From: Lynch, Karen
Sent: Monday, February 24, 2014 9:25 AM
To: 'Randy Dickamore'
Cc: Cyndi Baker; Kerrigan Diehl; Robert Suarez; Morero, Enza; Daniels, Charles; Winter, Jim
Subject: RE: PTS# 321299_Verizon Teepee_Part 4 of 4
Attachments: Revised Exhibit A - SCR.pdf

Jim/Charlie,
Please see attached revised orientation of the equipment for Teepee. As you know we are currently under CX at this site. During our preliminary mark out work our team rightly identified that the footings of the equipment enclosure were going to be impacting roots from the adjacent tree to the south. We consulted with a certified arborist, Jeremy Rappoport, President of Rappoport Development Consulting to discuss viable solutions. The suggestion was to relocate the shelter 10' north at a minimum and 16' at an optimal design as the 16' allows us to completely eliminate the conflict with the existing tree canopy and drip line.

TEEPEE
TORREY HIGHLANDS PARK, LANSDALE DR.
SAN DIEGO, CA 92130

APPROVED EXHIBIT "A" FOR PROCESS 1 APPROVAL

A-1

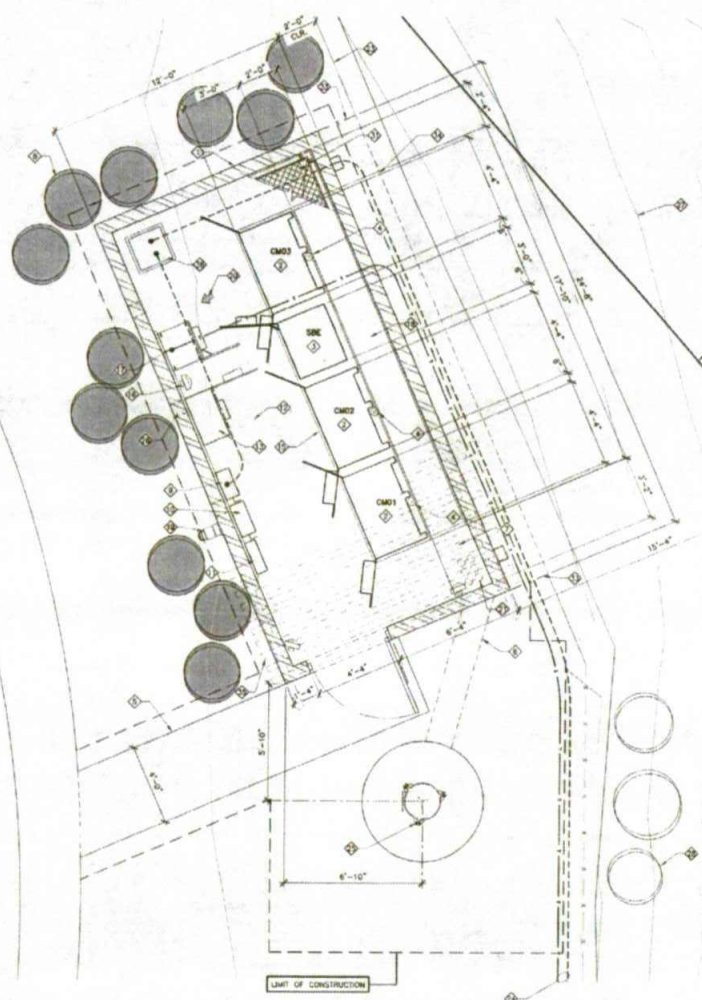
Sort of looks like one of the existing Torrey Pines moved along with your enclosure (attached). I do remember you were shoehorning your enclosure and tree in between Torrey Pines. Can you verify?

Consequently we've revised the A-1 sheet outlining this change. The original equipment footprint is shown dashed. I've included the original Exhibit A for your use as well. If all meets your approval, we are prepared to complete this as a field change so that CX can continue while we process a CX plan change via DSD concurrently.

Thanks Robert. As long as you stay outside the dripline of the existing trees, we have no issue with the proposed relocation of your equipment.

We are putting the enclosure between the two existing Torrey pine. The new location will work well with out being under the canopy of the existing tree.
